ANN ARBOR HISTORIC DISTRICT COMMISSION

Staff Report

ADDRESS: 407 S Seventh Street, Application Number HDC24-0111

APPLICATION: The applicant seeks HDC approval to build a two-story rear addition with a car port.

A-1

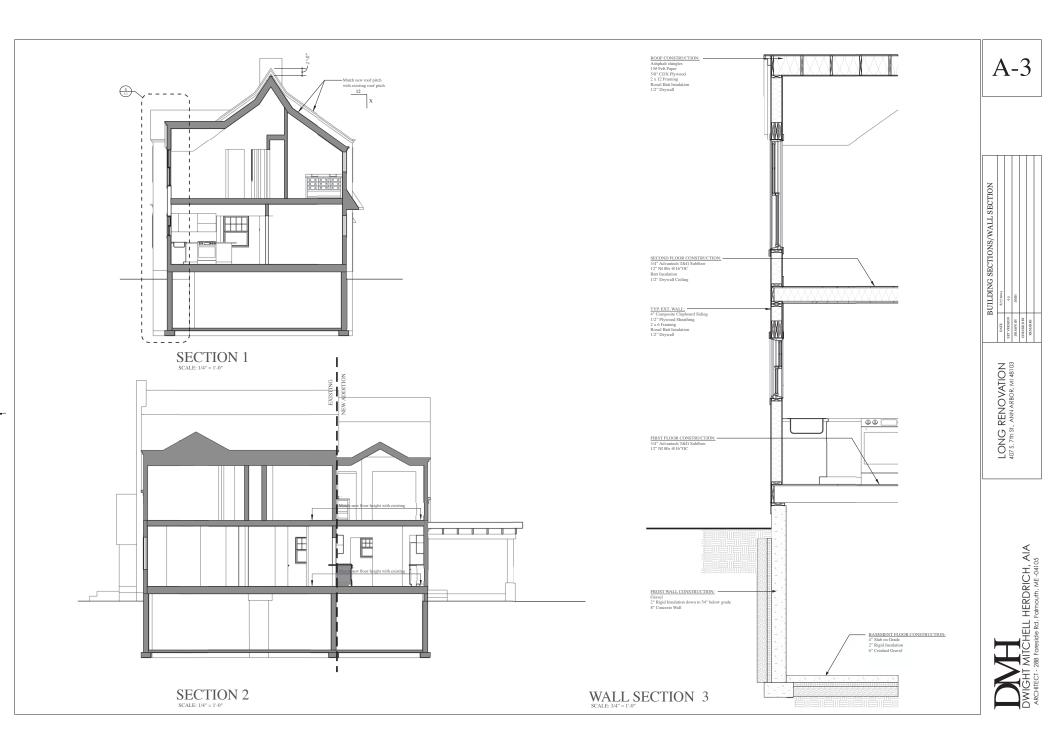
- 1. A two-story addition that closely mimics the existing house is proposed on the rear elevation. The addition is narrower and shorter than the house: the north sidewall is inset 10" and the new roof ridge is 1' below the existing. The south elevation bumps out from the current back corner, but the plane of the new wall is 2' farther north than the plane of the wall closer to the street. Roof pitches and styles match the existing.

- 2. Windows on the addition are clad wood Andersen or similar. They are 8/1 and 6/1 sashes like the historic part of the house, but the proportions are changed: on the south side elevation there is a pair of larger windows and a pair of smaller windows than the originals; on the north side the addition's windows are considerably smaller. The dimensions of the windows on the rear look similar to the second floor windows on the front of the house; staff has asked for clarification on window sizes.

- 3. The house is currently clad in asbestos shingles with a slightly wavy edge. Staff does not know whether this was the original siding or if there is an underlying layer. Cementitious lap siding is proposed for the addition, with wood trim.

- 4. The carport is a pergola design with a solid wall on the north elevation. The two posts are quite formidable and may be too heavy in appearance; staff has requested carport details for clarity.
